Town of Franklin

Planning Board

August 17, 2020

162 Grove Street
Special Permit & Site Plan | <i>Adv.: June 15 & June 22, 2020</i>
<i>Abuts: June 15, 2020</i> |

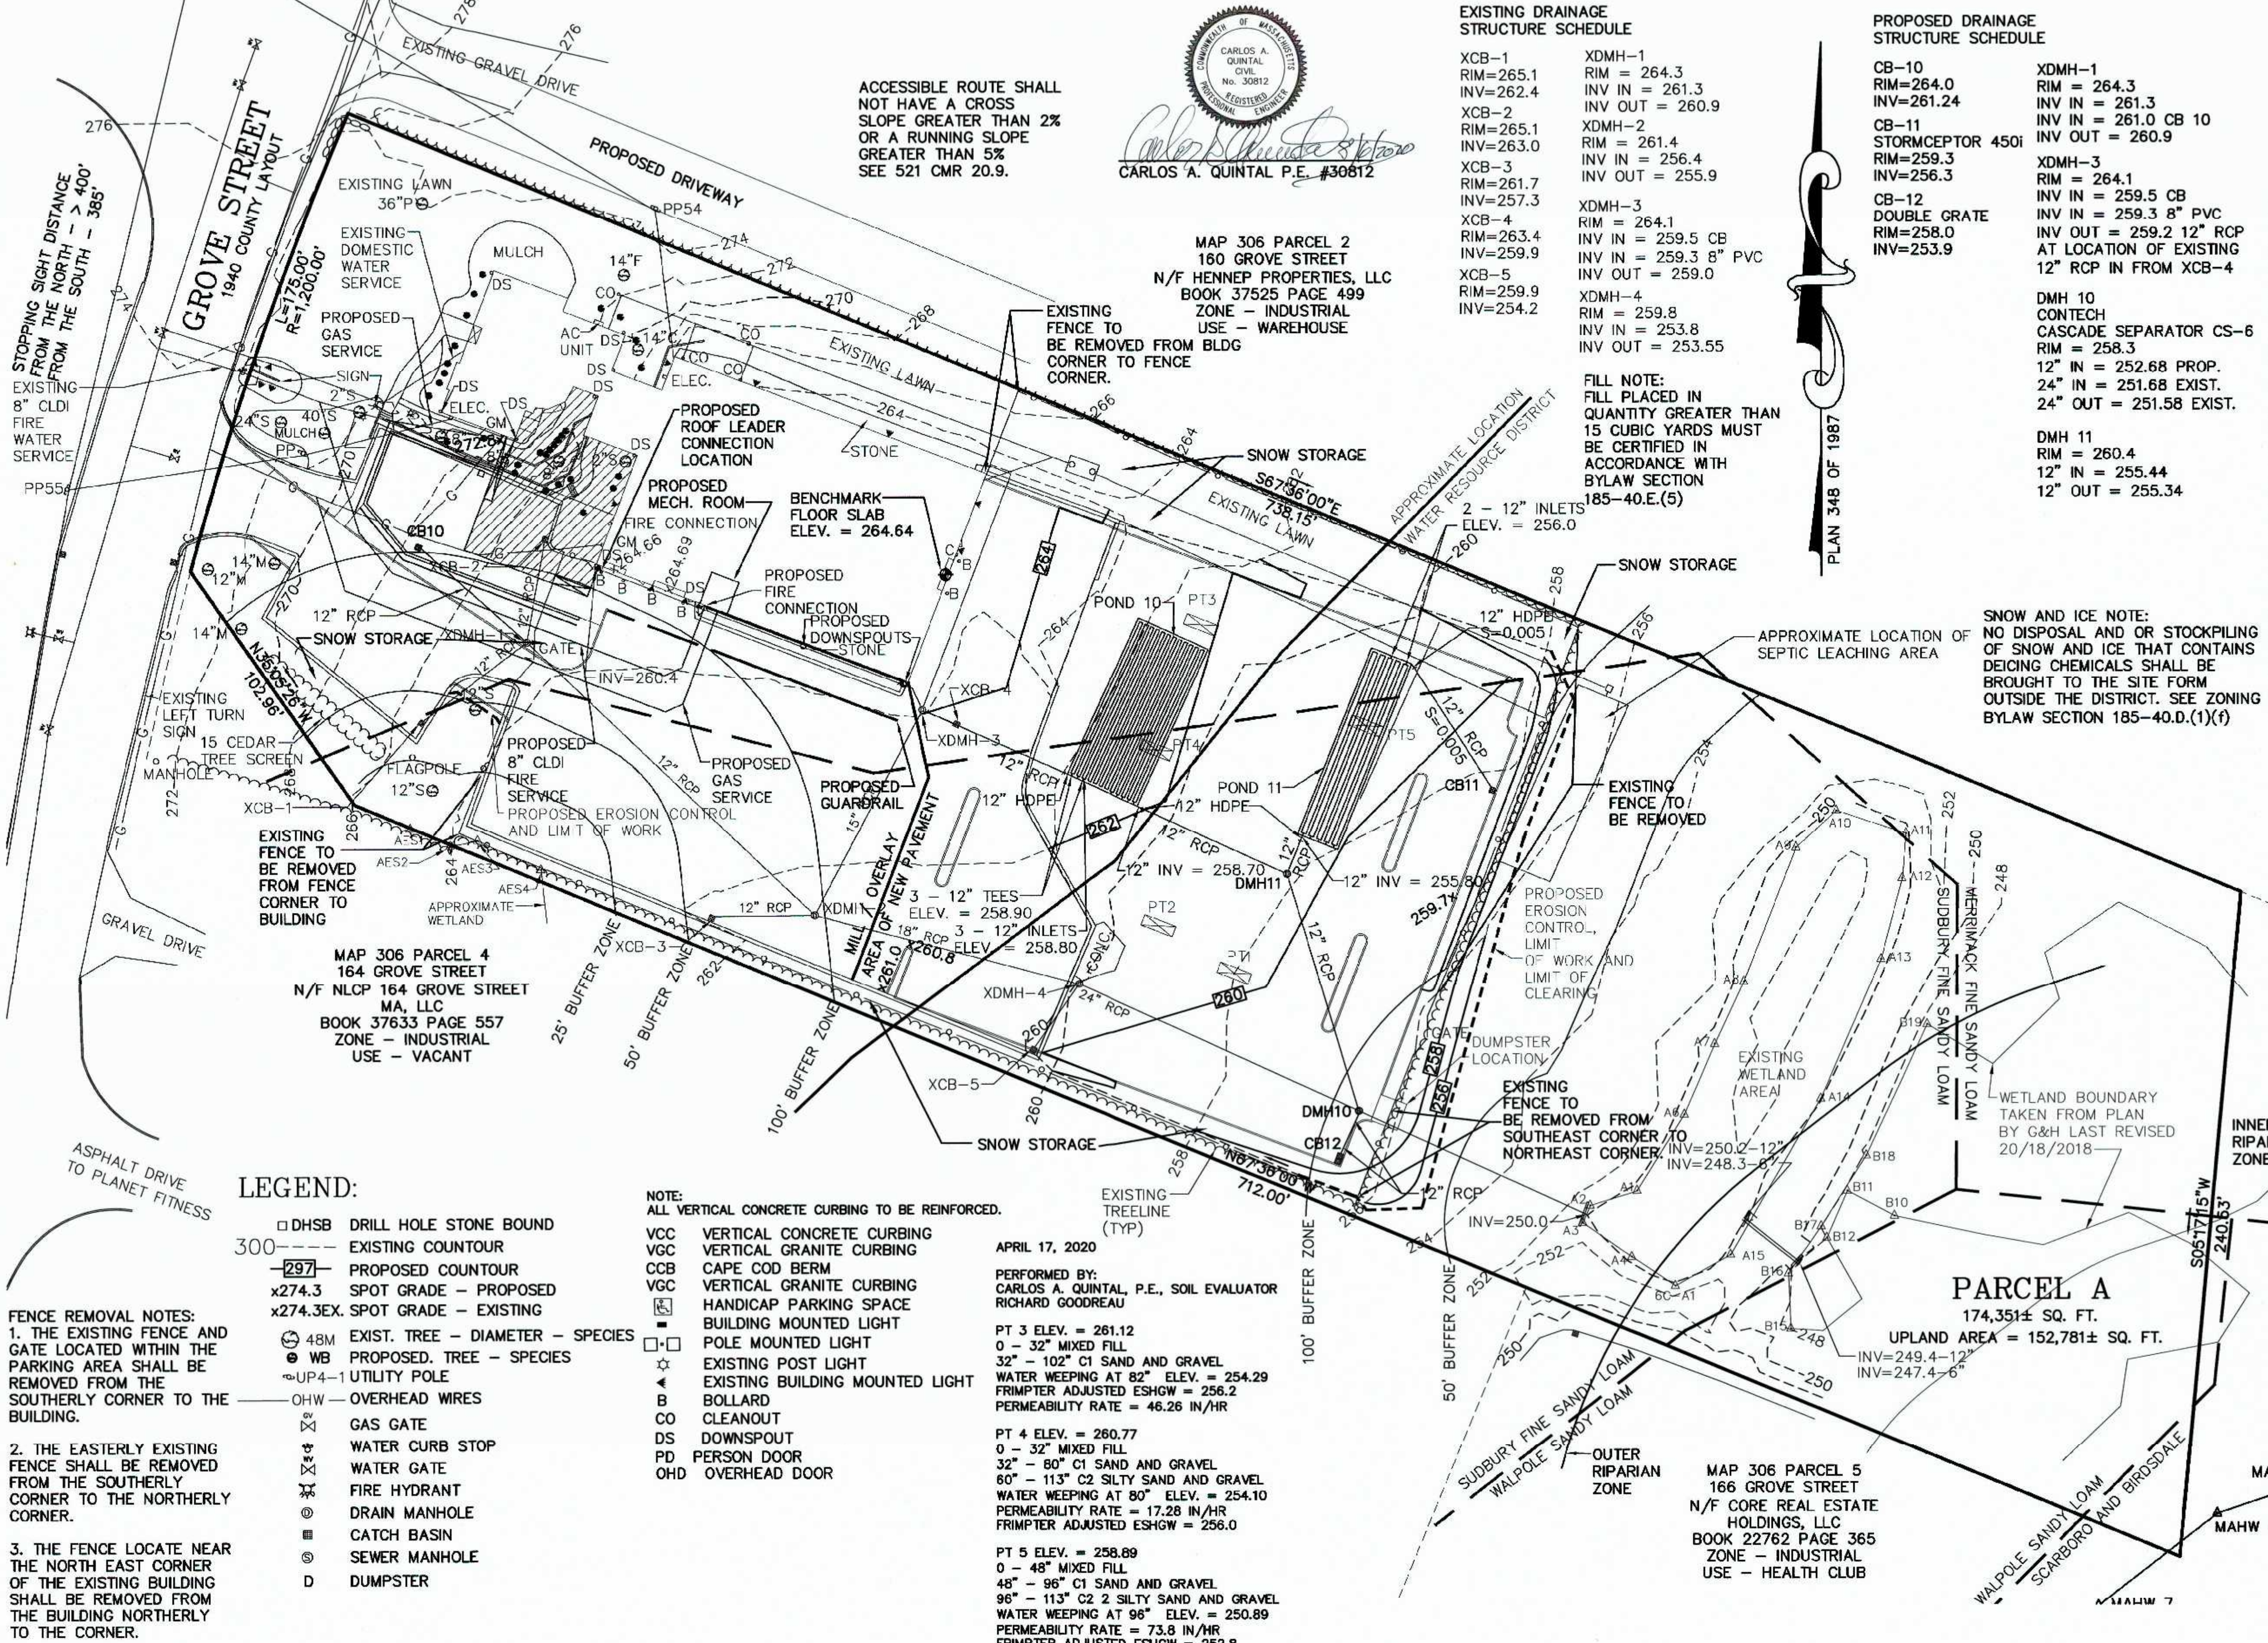
- G3. Confirm the limits of existing fence to be removed, particularly in the area of the site entrance. *UCI: Three fence removal notes have been added and the existing notes have been clarified on sheet 4.* **BETA2: Clarification provided – issue resolved.**

- G5. Indicate the limits of new pavement, pavement reconstruction, or any mill/overlay. *UCI: The limits of new paving/mill have been labeled on sheet 4.* **BETA2: Information provided – issue resolved.**

- S2. Indicate proposed snow storage locations on the plans (§185-31.C.(3)(i)). *UCI: Snow storage areas have been added to sheet 4. A note referencing zoning bylaw section §185-40D(1)(j) has been added to sheet 4.* **BETA2: Snow storage areas provided – issue resolved.**

- S4. Depict existing tree line and limits of clearing on the plans, as applicable (§185-31.C.(3)(u)). *UCI: The existing tree line and the limit of work label has been revised to include limit of clearing on sheet 4.* **BETA2: Information provided – issue resolved.**

- WR1. Confirm the estimated sewage flow for the on-site disposal system does not exceed 110 gallons per 10,000 sq. ft. of lot area (§185-40.D.(1)(i)). *UCI: The requested confirmation and supporting calculations have been added to sheet 4.* **BETA2: Information provided – issue resolved.**

- WR4. Note that any fill placed in quantity greater than 15 yards must be certified in accordance with §185-40.E.(5). *UCI: The requested note has been added to sheet 4.* **BETA2: Note provided – issue resolved.**

- SW2. Recommend labeling which drainage structures and pipes are to be removed/abandoned. *UCI: The removal protocol for the existing 15" RCP pipe connecting X-DMH3 to X-DMH2 has been added to the stormwater system construction note 3 on sheet 4.* **BETA2: Information provided – issue resolved.**

DUMPSTER AREA GRADING DETAIL
N.T.S.

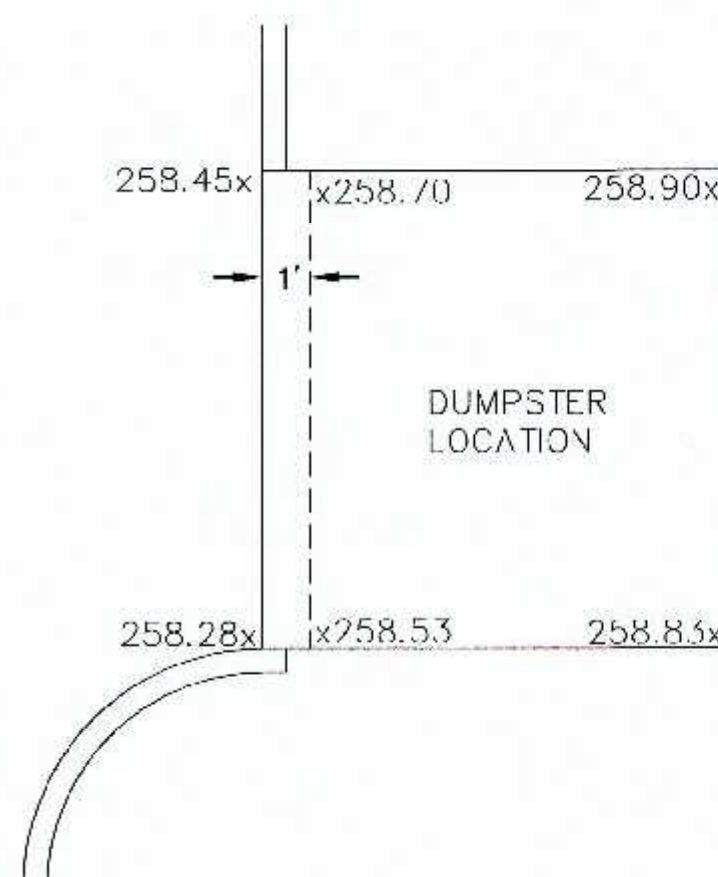
- SW4. Provide detailed grading in the area of the dumpster pad to ensure stormwater flow is not directed through the enclosure, bypassing the stormwater management system. *UCI: A dumpster grading detail was added to sheet 8.* **BETA2: Grading detail provided – issue resolved.**

CONTECH CASCADE SEPARATOR DETAIL
 N.T.S.

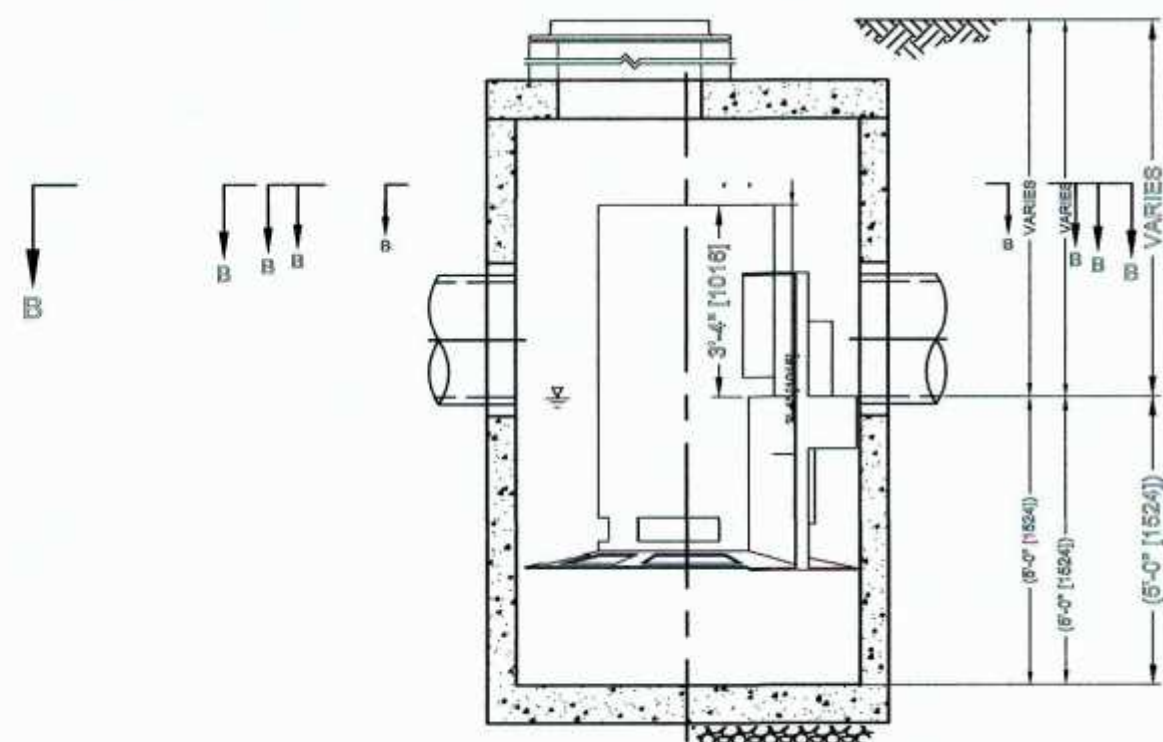
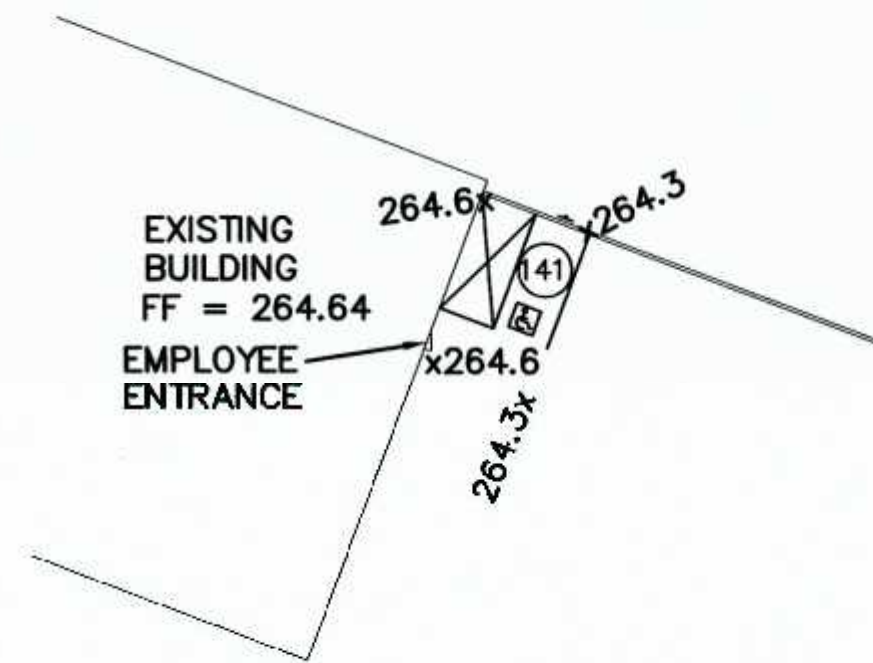
- SW3. Provide detail for CDS unit. *UCI: A detail of the proposed Contech Cascade Separator Model CS-6 has been added to sheet 9.* **BETA2: Detail provided – issue resolved.**

SW13. Provide documentation of third-party testing that demonstrates the 75% TSS removal rate for the CDS unit can be achieved. *UCI: The CDS unit has been revised. A detail of the proposed Contech Cascade Separator Model CS-6 has been added to sheet 9. Refer to the revised stormwater report for revised TSS removal rates. BETA2: TSS rate revised – issue resolved.*

DATE
 MAY 21, 2020
 SCALE
 1" = 30'
 PROJECT
 UC1435
 SHEET
 9 of 9

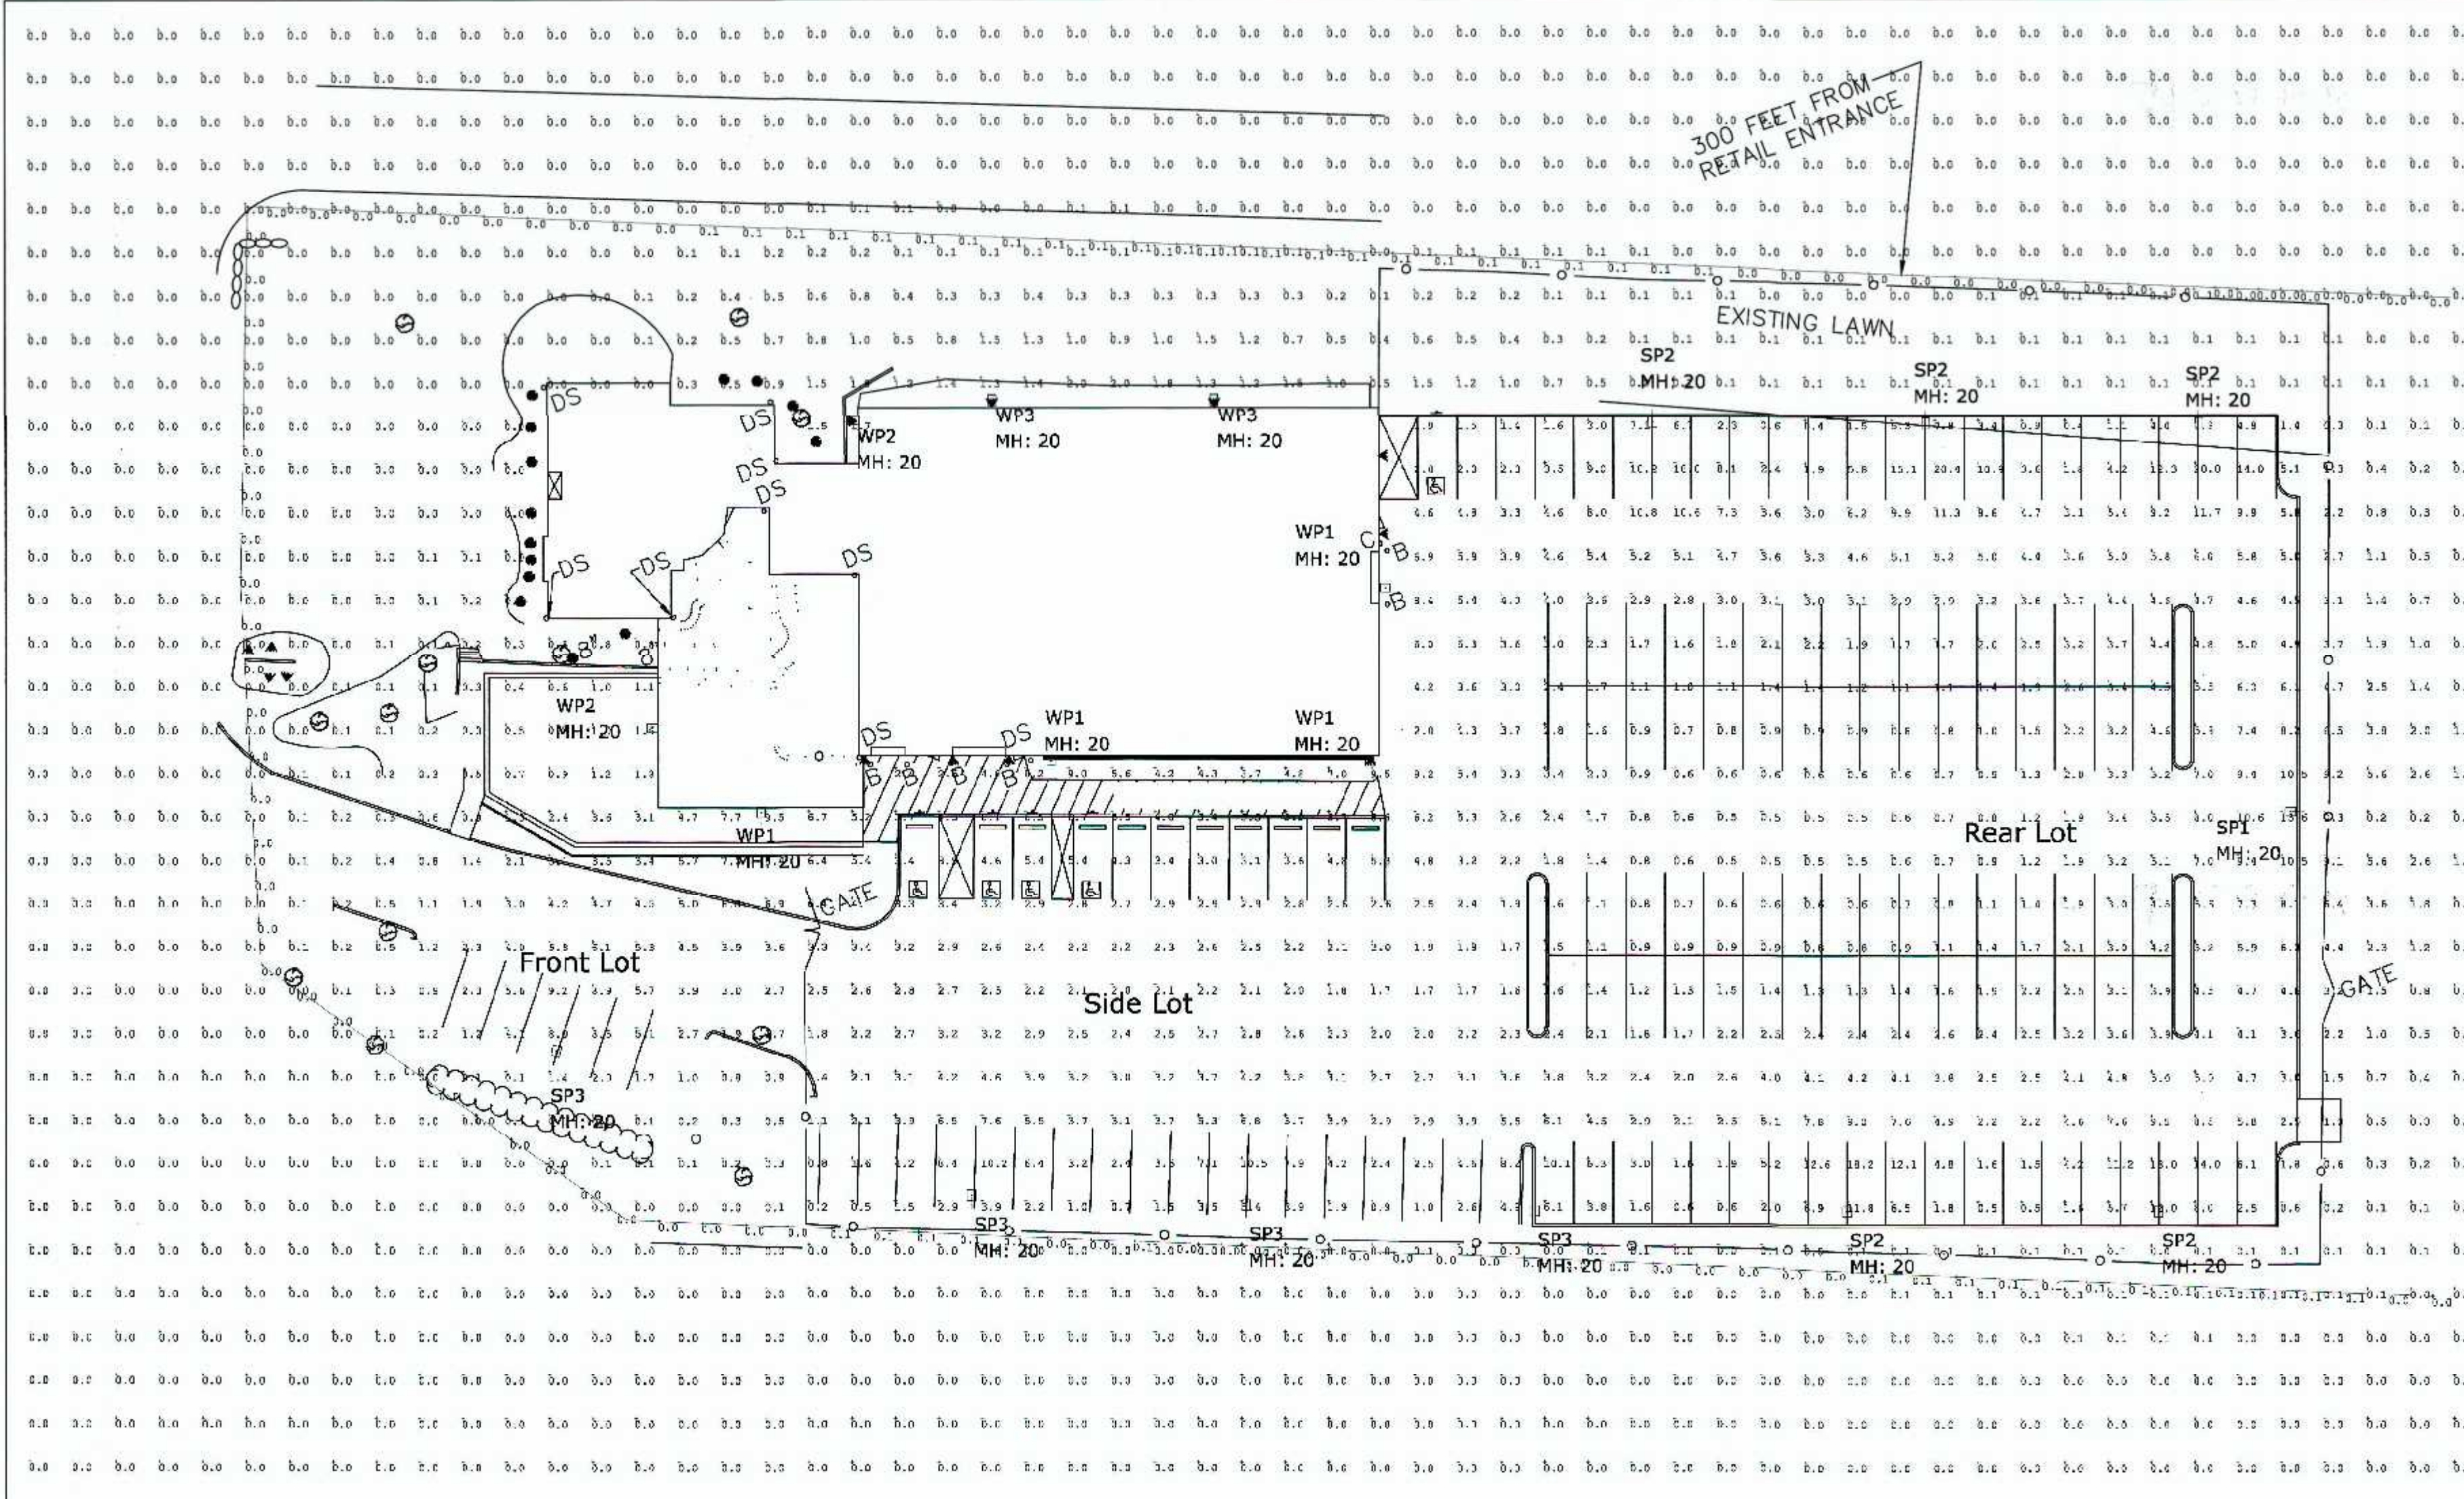
- G1. Provide safety fencing along the top of wall on the western end of the courtyard area that abuts the exiting walkway. *UCI: The proposed fence location has been added to the detail on sheet 9.* **BETA2: Fencing provided – issue resolved.**
